PONTIAC

Service Craftsman News

No. 6 S-295

June, 1957

Fig. 1 3-2 Detent Oil Passage

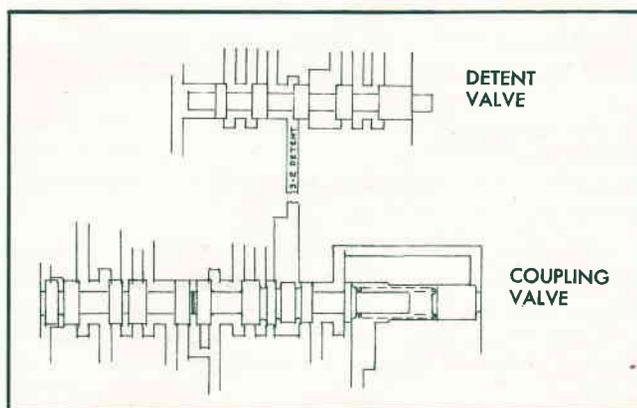
The clutch valve body in the 1957 Hydra-Matic transmission has been revised to provide a 2-1 detent downshift which will prevent engine "lugging" under extreme load at low car speed. The revised body directs 3-2 detent oil to the coupling valve (Fig. 1) to close the valve, causing a 2-1 downshift when the transmission is in second speed up to approximately 10 mph.

Coincident with this change and to prevent the possibility of an upshift in reverse, the coupling valve outer spring has been eliminated, and the coupling valve plug bore has been reduced to accommodate a smaller diameter plug.

Fig. 2 Optional and Revised 1957 Clutch Valve Bodies

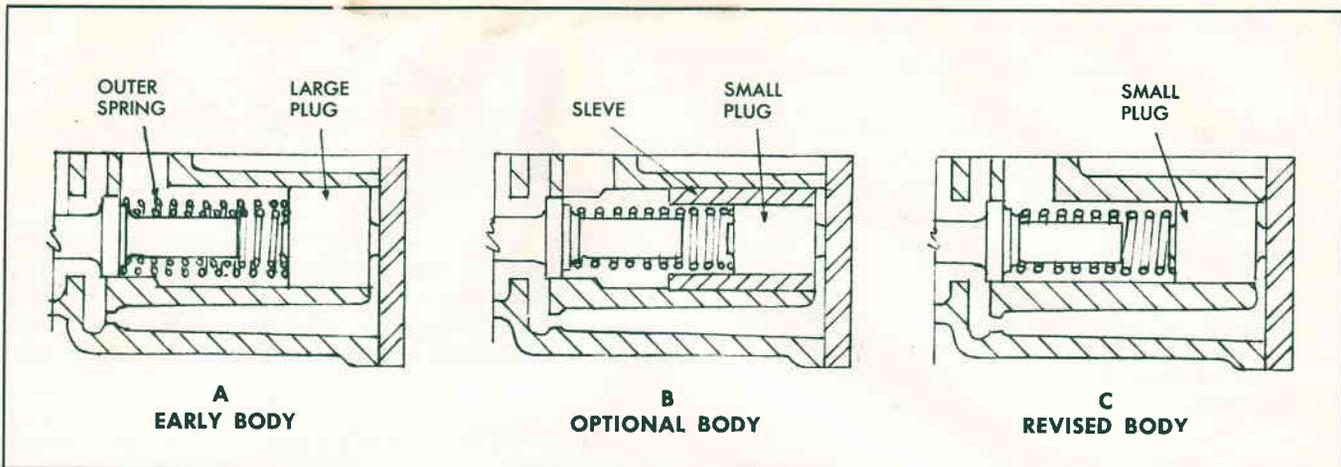
In order to facilitate the above improvement, some transmissions were built using the early clutch valve body with a sleeve pressed into its bore and outer spring omitted, as shown in Fig. 2-"B".

Fig. 2-"A" illustrates the early design with inner and outer springs with the large diameter valve plug, Fig. 2-"B" is the optional or intermediate design, while Fig. 2-"C" shows the revised body with inner spring and smaller plug.

Channel plate, part No. 8618224 is used with the early clutch valve body Fig. 2-"A". Channel plate, part No. 8618195, is used with the optional and revised bodies (Fig. 2-"B" and 2-"C"). Channel plates are identified by a part number engraved in the panel on the plate.

Do not mix clutch valve bodies and channel plates.
